Addendum 3
RFP# 19-05AA
RFP Develop and Implement an Energy Service Micro-Grid System

This addendum serves to notify all bidders of the following changes to the solicitation documents:

SER. NO. **24-366**
NEMA CLASS AA DRY TYPE TR

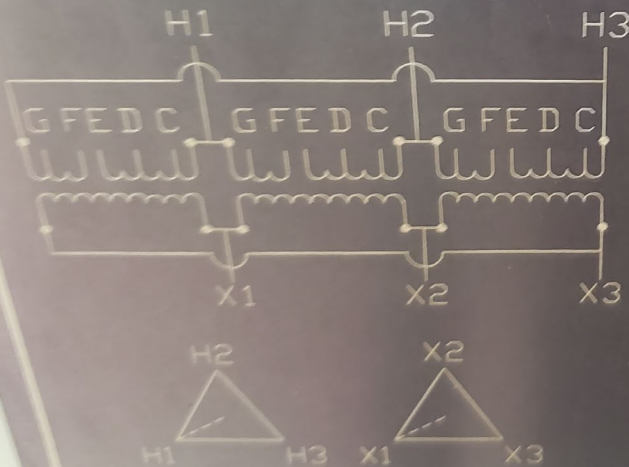
A more clear picture of the 2300V transformer name plate is attached.
